# Access Compliance Report

## Public Rights-of-Way

Intersection ID: 21549	Main Street: S_TRYON_ST	Cross Street: SANDY_PORTER_RD	Location: NW
ADA ID: 81E835473AE4	Ramp Type: IslandPerp	Initial Pass/Fail: Fail	Overall Compliance: No
		Severity Score: 12.5

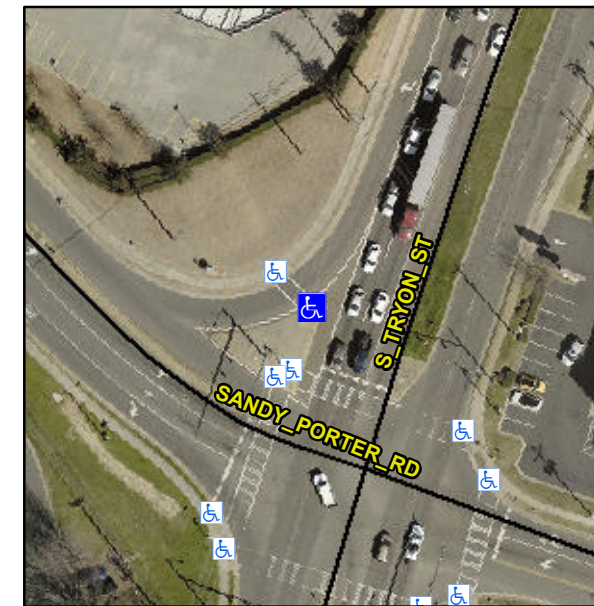
**Not Found, R304.2.2**

Compliance	Description	Data	Compliance	Description	Data
N/A	Ramp Length (in)	59.0	No	Ramp Slope (%)	10.1
Yes	Ramp Width (in)	55.0	Yes	Ramp XSlope (%)	1.8
N/A	Flare Type LT	N/A	N/A	Flare Type RT	N/A
N/A	Flare Slope LT (%)	N/A	N/A	Flare Slope RT (%)	N/A
N/A	Flare Traversable LT?	N/A	N/A	Flare Traversable RT?	N/A
N/A	Landing Length (in)	N/A	N/A	DWS Provided?	N/A
N/A	Landing Width (in)	N/A	N/A	DWS Contrast?	N/A
N/A	Landing Slope (%)	N/A	N/A	DWS Length (in)	N/A
N/A	Landing X Slope (%)	N/A	N/A	DWS Full Width?	N/A
N/A	Landing Curb? (Y/N)	N/A	N/A	DWS Offset (in)	N/A
N/A	Shared Landing?	N/A			
N/A	Gutter Ponding?	N/A	N/A	Gutter Slope (%)	N/A
N/A	Gutter Lip Ht (in)	N/A	N/A	Gutter X Slope (%)	N/A
N/A	Painted X Walk1?	Yes	N/A	Painted X Walk2?	N/A
	X Walk 1 Direction	To N		X Walk 2 Direction	N/A
N/A	X Walk 1 Width (in)	82.0	N/A	X Walk 2 Width (in)	N/A
	X Walk 1 Slope (%)	3.8		X Walk 2 Slope (%)	N/A
	X Walk 1 X Slope (%)	0.6		X Walk 2 X Slope (%)	N/A

**Remove & Replace Entire Ramp.**
